NOTICE OF INTENT PLAN

SITE PLAN FOR
43 OLD BEDFORD ROAD
CONCORD, MASS.

Planting Plan

Narrative Analysis for request for a waiver from the 50 foot no touch zone.

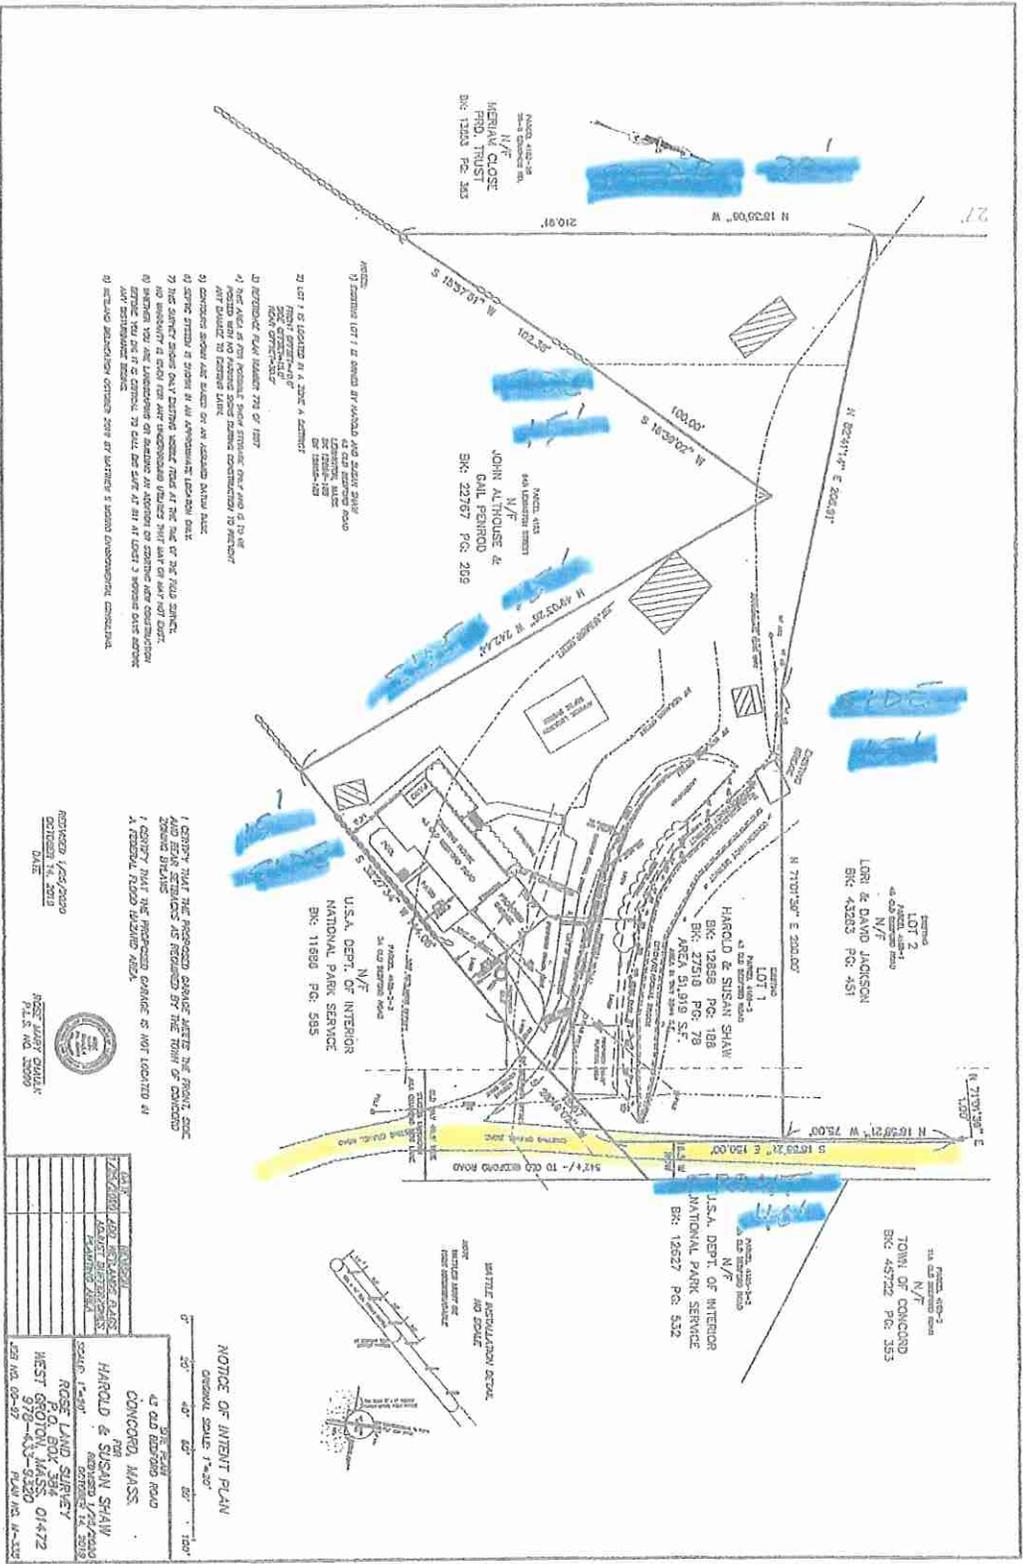
43 Old Bedford Road is not a corner lot, it has a front and rear setback and all other property lines are side setbacks. I have attached a copy of a marked up plan for you to review.

The building commissioner had taken the initial drawing and hand wrote *and* highlighted the setbacks for each area of the lot. The information submitted by the building commissioner was considered by Rosemary Chaulk. The proposed attached garage has been optimized to maintain maximal distance from the resource area without causing a zoning non conformance. This has resulted in a minimized amended proposal showing only 93 square feet within the inner 50 foot, no closer than 40 feet to the resource area.
